To: Brian Rossi
From: Gilbert Combs, Associate Planner; 910-341-4661
CC: File;
Date: 5/3/2019
Re: Hendrick Honda Rev2

CITY OF WILMINGTON, NEW HANOVER COUNTY, NORTH CAROLINA
SITE IMPROVEMENT PLAN
FOR
HENDRICK HONDA OF WILMINGTON
6720 MARKET STREET
OVERALL LANDSCAPE PLAN

DATE
February 11, 2019
SCALE
1" = 50'
JOB NO.
20180410
SHEET
L2.0

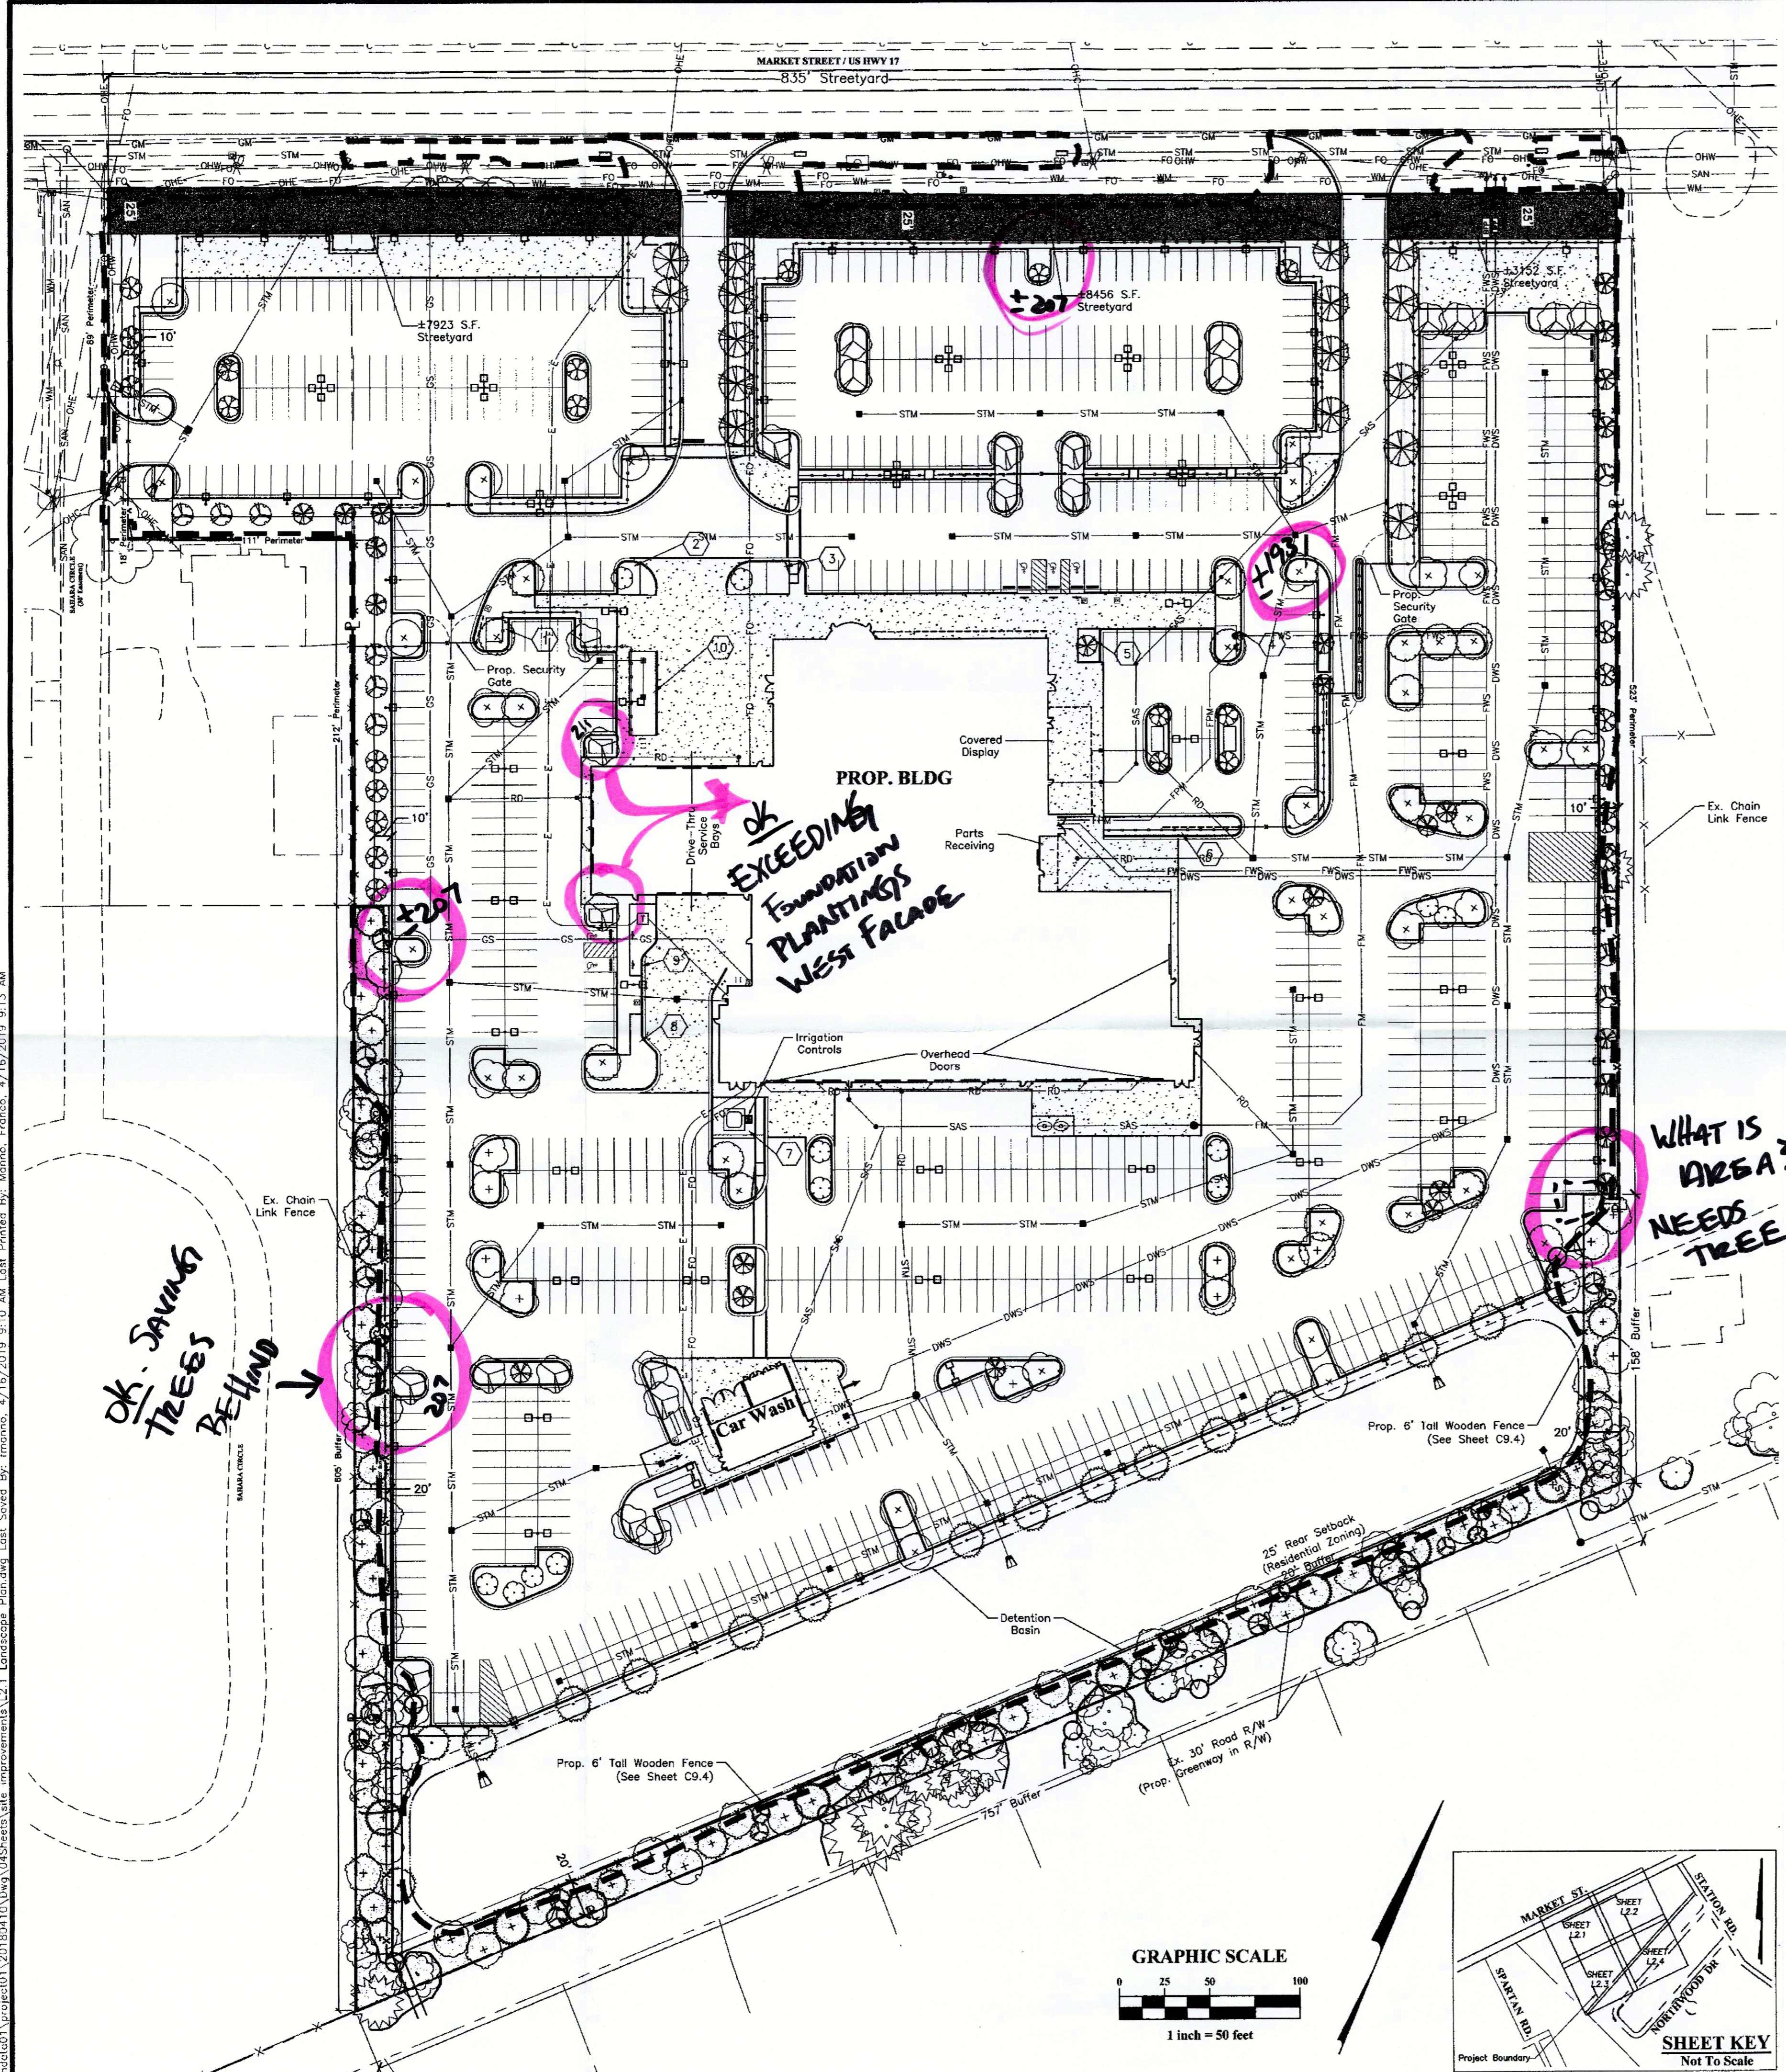
- Parking islands at the ends of consecutive parking rows must have a minimum width of 12 feet measured from back of curb to back of curb and contain a minimum area of 216 square feet. These islands must contain at least one tree. [18-481(a)(g)]

- See attached sheet for areas that are not meeting the minimum requirement and adjust or provide reason why they can be waived per [18-481(h)]
- Ensure compliance with perimeter landscaping for area abutting Sahara Circle. A tree may be needed below the side entrance.

- Foundation plantings
 - Callout 1 on the main building is not located between building façade and parking/internal driveway.
 - Carwash callouts in data table may be mislabeled as 10/11 instead of 11/12.

- Carwash top area does not serve a parking row. Do not need to subtract.
 - Carwash foundation planting areas should serve the side they are associated with. Please adjust.

- Identify trees on the landscape plans that go beyond other landscaping requirements and serve as mitigation trees. Like many other requirements (foundation plantings, parking islands, etc) these cannot serve to meet more than one requirement.
